HISTORIC AND DESIGN REVIEW COMMISSION

HDRC CASE NO: 2021-355

ADDRESS: 515 CEDAR ST

OWNER: Kevin Moore/MOORE KEVIN P & DENISE L
TYPE OF WORK: Construction of a 1-story rear accessory structure

Floor Plan

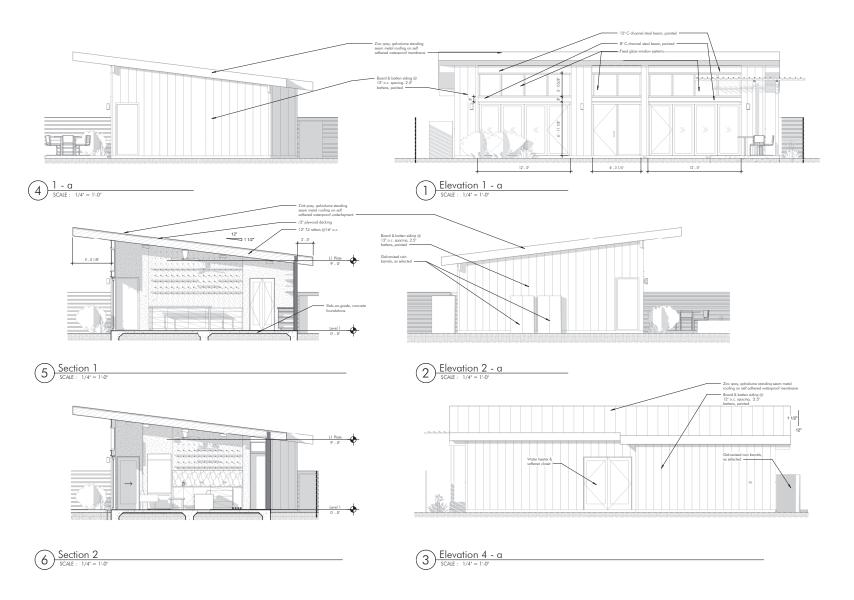
- c. SCALE AND MASSING According to Guideline 5.A.i for New Construction, new garages and outbuildings should be designed to be visually subordinate to the principal historic structure in terms of their height, massing, and form. The Historic Design Guidelines for New Construction state that new outbuildings should be no larger in plan than 40 percent of the principal historic structure footprint. The applicant has proposed to install a 1-story, 800-square-foot rear accessory structure. The primary structure is a 2 ½ -story, 3,700-square-foot structure. Staff finds the proposed scale and massing of the structure generally appropriate.

- precedent with a greater building to lot ratio. The applicant has proposed to construct an 800-square-foot rear accessory structure on a lot with an existing primary structure of approximately 3,700 square feet. Staff finds that the applicant should provide the percentage of proposed lot coverage for review.

i. That the applicant provides the percentage of total lot coverage to staff for review and approval based on finding
